SUBJECT: McDonalds and Petrol Filling Station – Weaver View

PROJECT: NW XX AUTHOR: LJB

PREVIOUS COMMENTS

Figure 1 Signs and Lines Plan

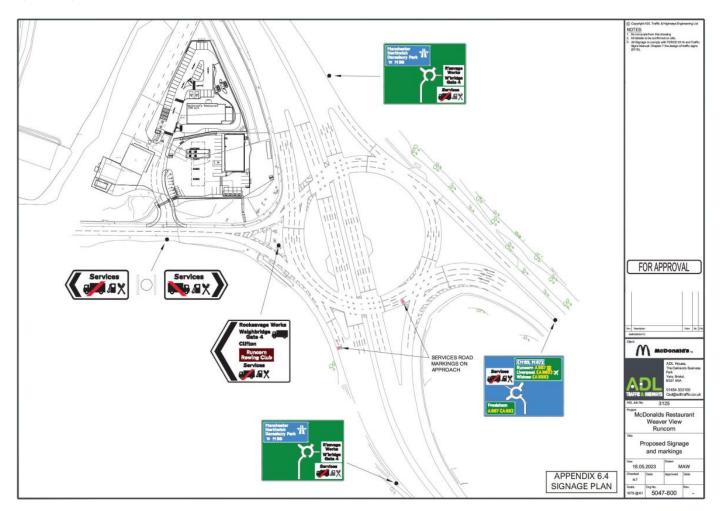
As shown in Figure 1 there are proposed changes to advance direction signs which are on or the SRN or will affect the SRN. The signs, in particular those on the off-slips show the proposed PFS and a 'services'. Given this, it is requested that ADL have liaise with National Highways' Roadside Facilities Team to discuss and agree a proposed signage strategy which accords with the relevant policies (DfT Circular 01/2022, DMRB and TSRGD).

It is also noted in Figure 1 that there are proposed changes to road marking on the Rocksavage Roundabout. It is requested that ADL confirm with National Highways' Third Party Works team that the proposed road marking changes are appropriate and will not impede on the safe operation of the junction.

Confirmation should therefore be provided that ADL have liaised with National Highways' Roadside Facilities Team and National Highways' Third Party Works team respectively.
